Doc.-Nr. 336-99-0005-00 Issue: 00 Page: 1 of 1	Service Information	Alexander Schleicher GmbH & Co. Segelflugzeugbau D-36163 Poppenhausen ADOA AP138
	Flap lever locking pin

Subject: Flap lever locking pin in the cockpit – focus during maintenance / inspection tasks

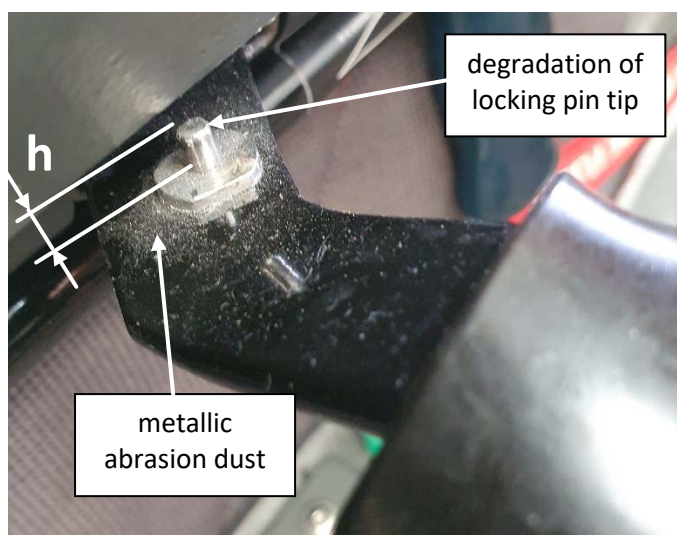
Excessive wear on the locking pin can be easily detected by metallic abrasion dust on the lever next to the pin or deformation / degradation of the pin:

The minimum height h of the locking pin must not be less than 4 mm (0.16 in).

Note: For serial production the flap setting plate was changed to minimize the possibility of excessive wear on the locking pin (AS 33 Es from S/N 33067; AS 33 Me from S/N 33551). The improved design can be retrofitted to existing aircrafts. The required spare part depends on the serial number:
